Case No./Name: Z24-29 MCCRANEY PROPERTY & PRD24-06 BEAR CREEK
Meeting Date: August 1, 2024
Request: Rezoning request and Planned Residential Development approval for a 132-site residential development.
Recommendation: Approval for Z24-29 and Approval for PRD24-06

Proposed use: A 132-unit planned residential development

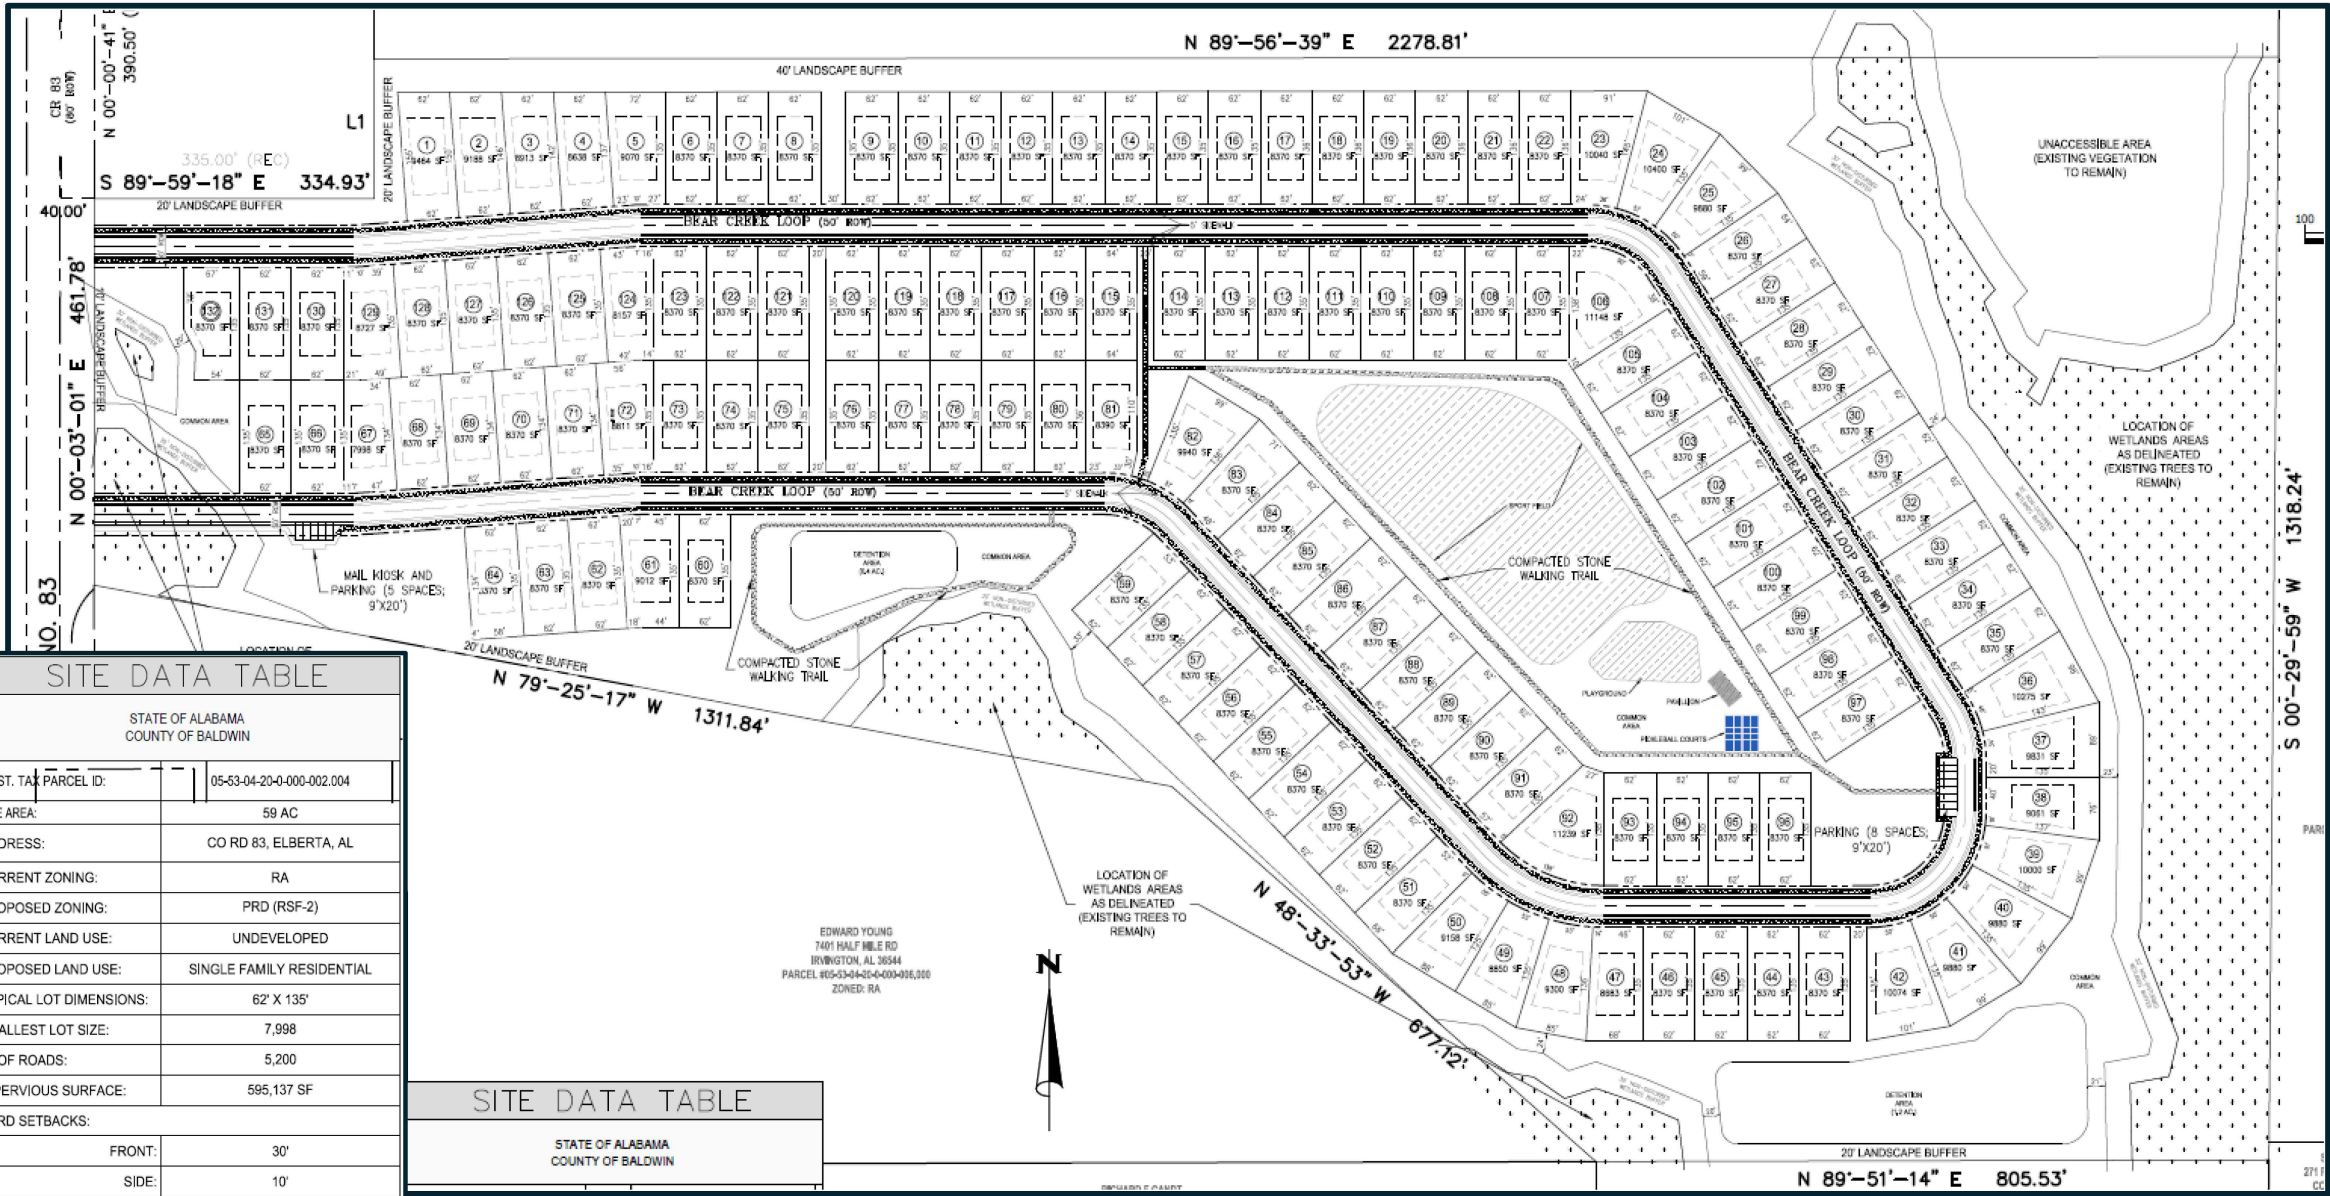
Town of Elberta, Caryn Woerner: For full disclosure, Town administration along with our consultant engineer reviewed this property for potential annexation several months ago at the request of the Engineer. Our initial concerns were toward drainage, wetlands, fire safety / impacts, police personnel impacts and traffic impacts so close to the High School and that coordination with the county for review would be needed for the commercial turn out permitting. Minimum R1 Single Family Residential lots of 100 x 150 would have been required as we currently have a moratorium on Planned Unit Development applications as new / updated regulations are being prepared.

Some questions that come to mind with PRD zoning are: Are there offsetting benefits to the community/residents in allowing a PRD with smaller lot sizes which brings added traffic in close proximity to the High School and the new middle school proposed a few miles north on the 2-lane roadway? Are there right of way improvements proposed for County Road 83 to offset traffic impacts? This site has wetlands along with some of the bordering sites. Are there protections required for all wetlands? Are these narrow internal right of ways wherein parking on both sides of the streets is likely due to the smaller lot sizes and less parking area available for each lot as we see in many other subdivisions in our nearby communities? Are there plans to combat parking in the streets which can cripple emergency responders trying to navigate same?

It is likely that additional assistance from the Baldwin County's Sherriff's Office within the Elberta area may be needed due to the population increases with the RV parks, subdivisions, etc. that are being developed / proposed within Elberta's police jurisdiction, County Road 95, County Road 20 and the Lillian areas. At this time, Elberta has no paid EMT personnel or Fire Department personnel and those who serve work full time jobs outside their volunteer work. Early morning last week, we had a house on fire within our police and fire jurisdiction and thankfully other departments provided mutual aid to get the structure fire under control.

We realize that Baldwin County as a whole is experiencing growing pains and in response, Elberta has updated various regulations recently in an effort to be mindful growth stewards of our community. I'm sure that county representatives will weigh the issues such as limited infrastructure, small workforces, drainage and the traffic impacts it brings to our 2 lane rural roadways as they review the proposed PRD request and it is sincerely appreciated. If approved, our consultant Engineer would like the opportunity to review the drainage plans due to the proximity of the property to some existing drainage issues the town currently experiences downstream.

DEVELOPER'S PLAN

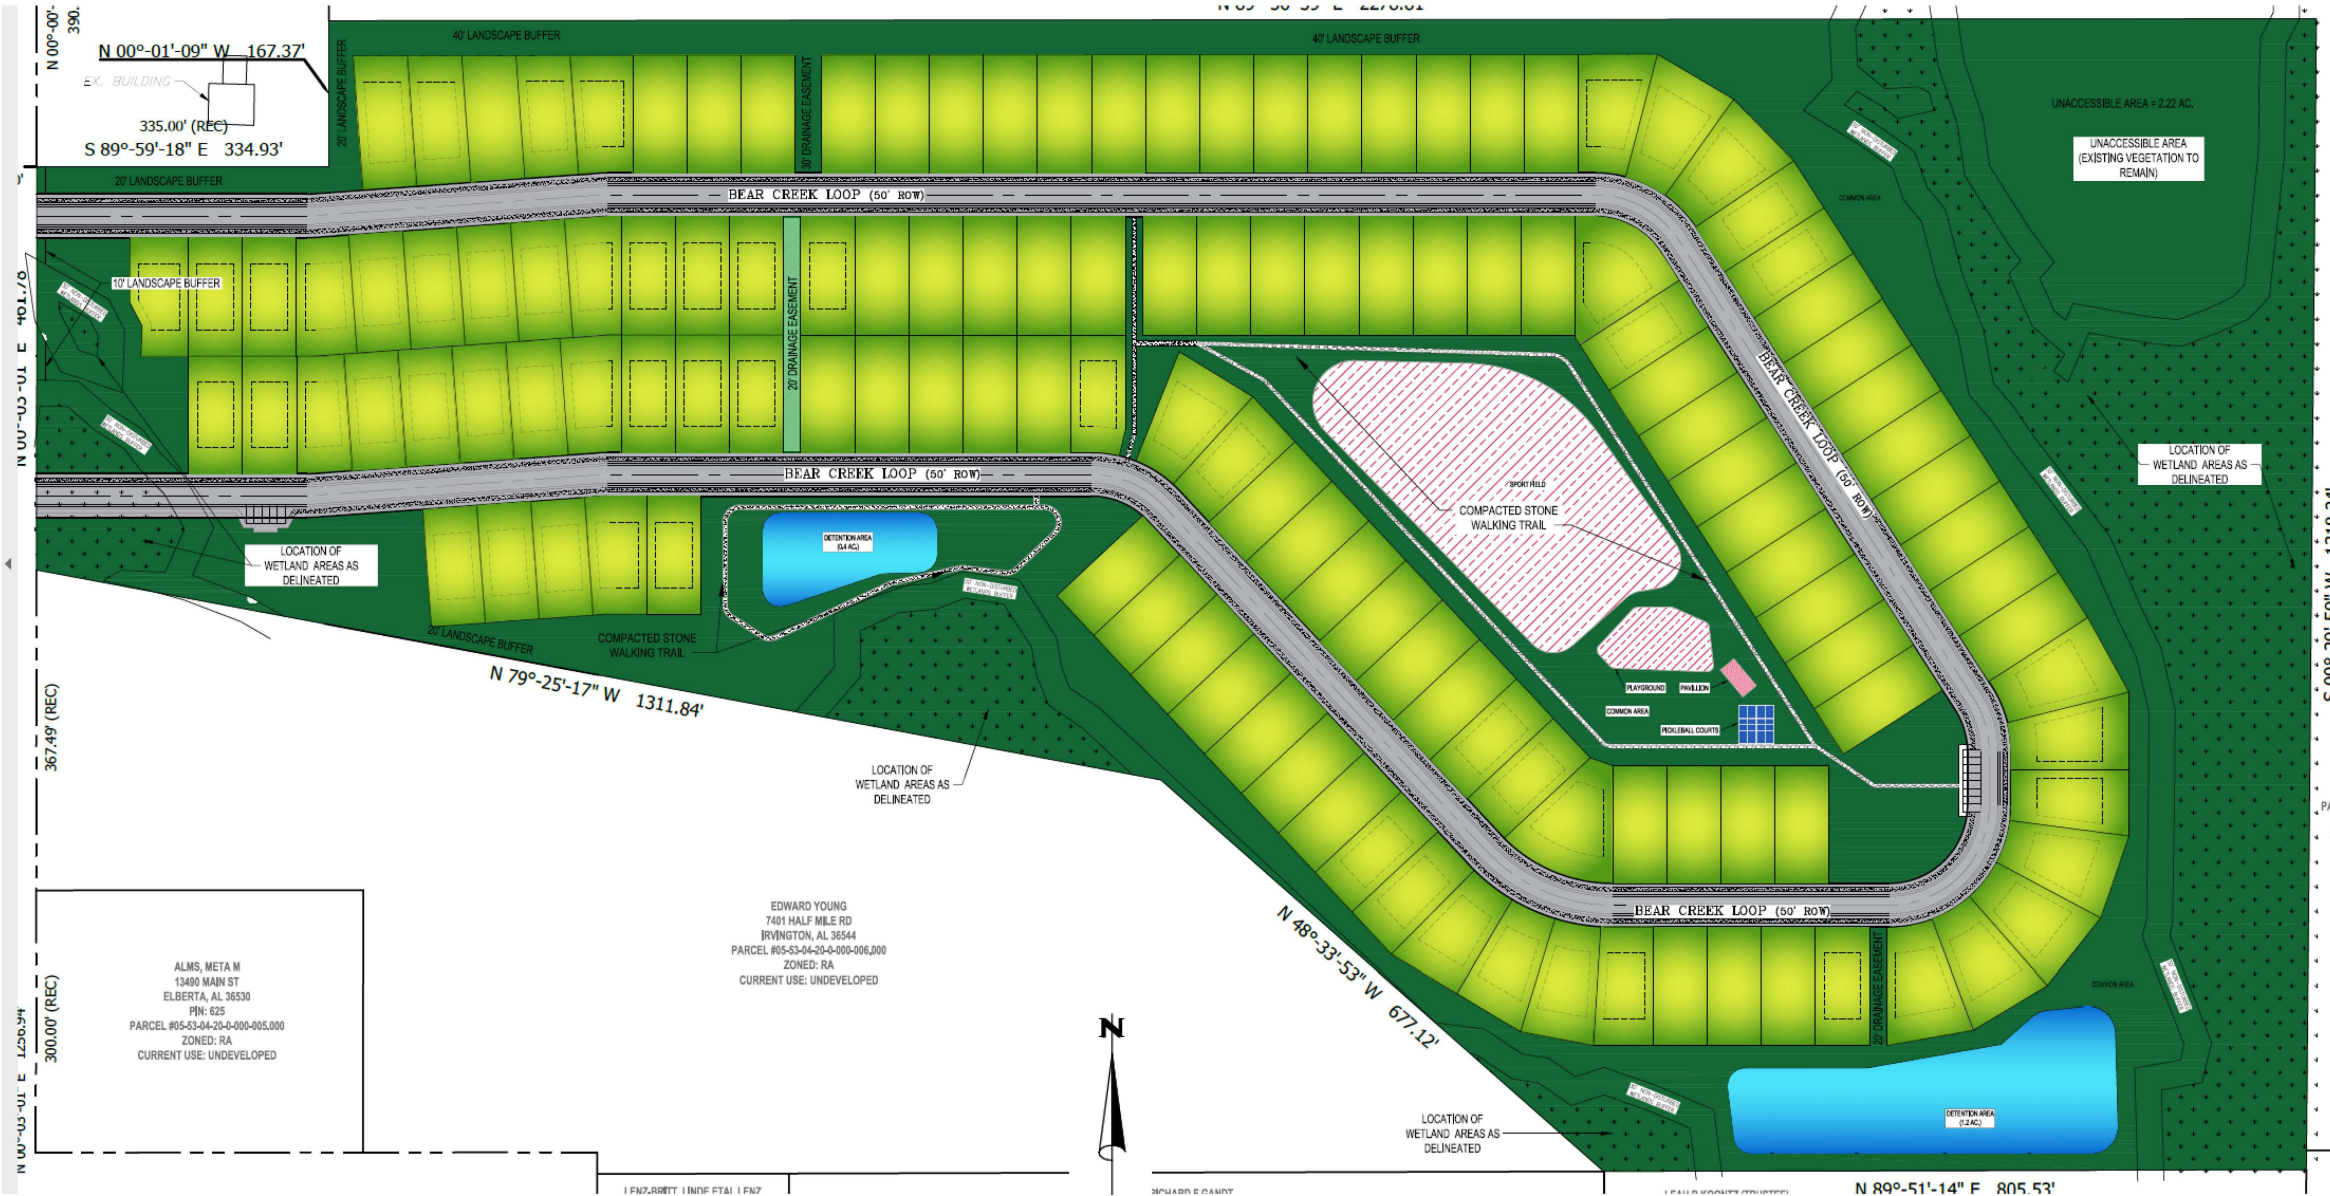
40 ft buffer required adjacent to agricultural use

20 ft buffer

1. Approval of the rezoning request from RA to RSF-2.
2. During construction plan review, if the detention ponds must be enlarged, the area of open space shown on this site plan must be maintained.
3. If USACE permits for wetland fill are denied and only one subdivision entrance is provided, the number of lots must be reduced to 50.
4. The Traffic Impact Study shall be conducted while public and private schools that will serve the proposed development are in session.
5. Details for all amenities must be submitted during preliminary plat review.
6. Fire flow must meet ISO requirements for home spacing (1000+ gmp at 20 psi for spacing between 11-20 feet). If building setbacks must be increased, the amount of open space reflected on the site plan must be maintained

Landscape Plan

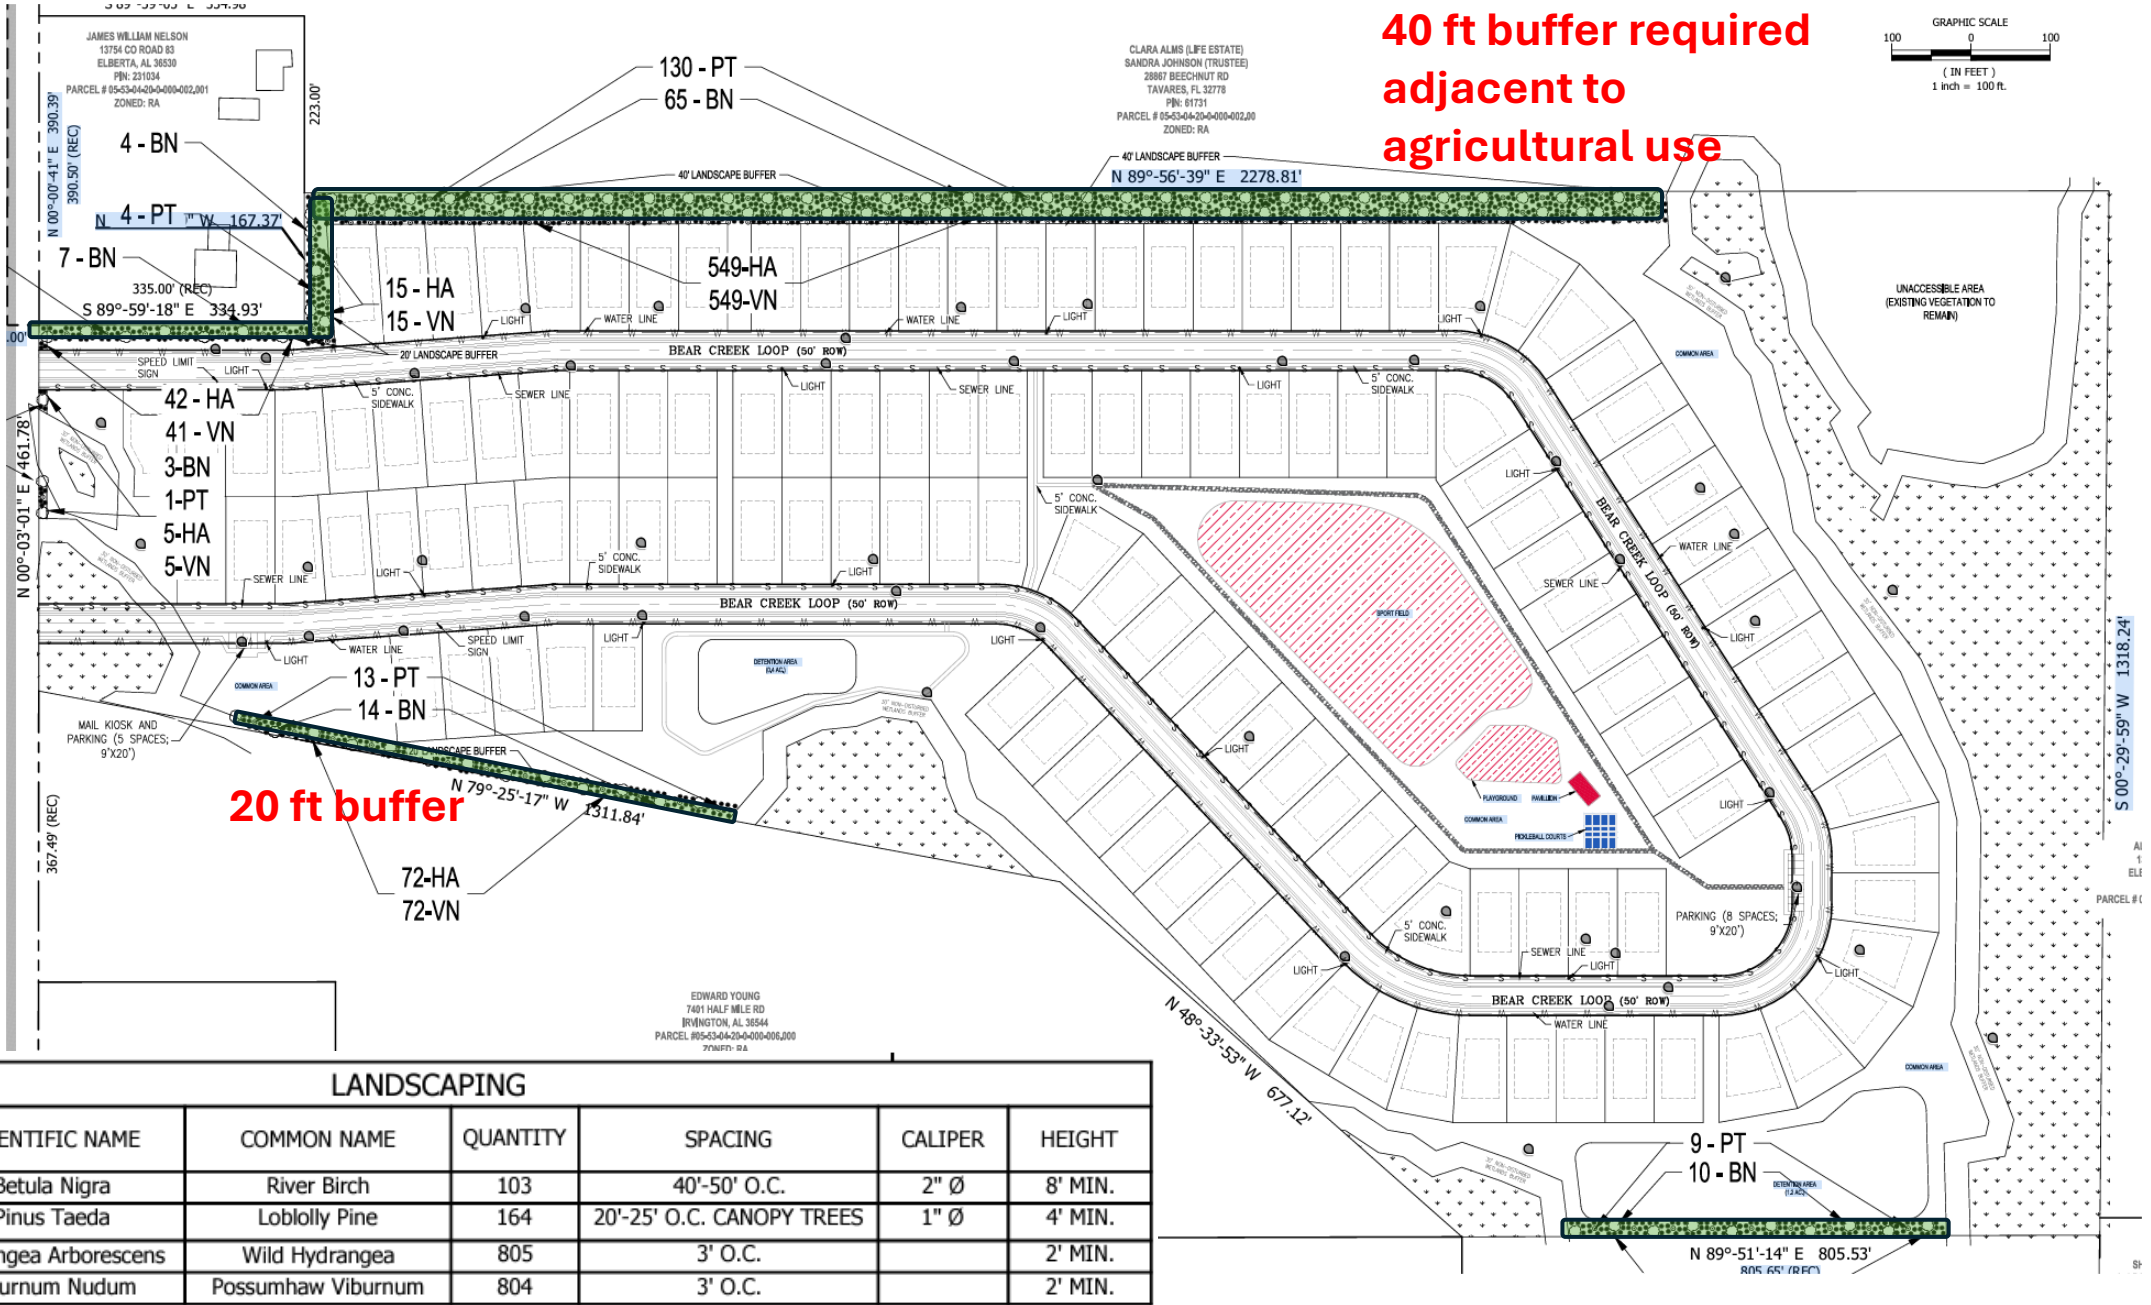
20 ft buffer
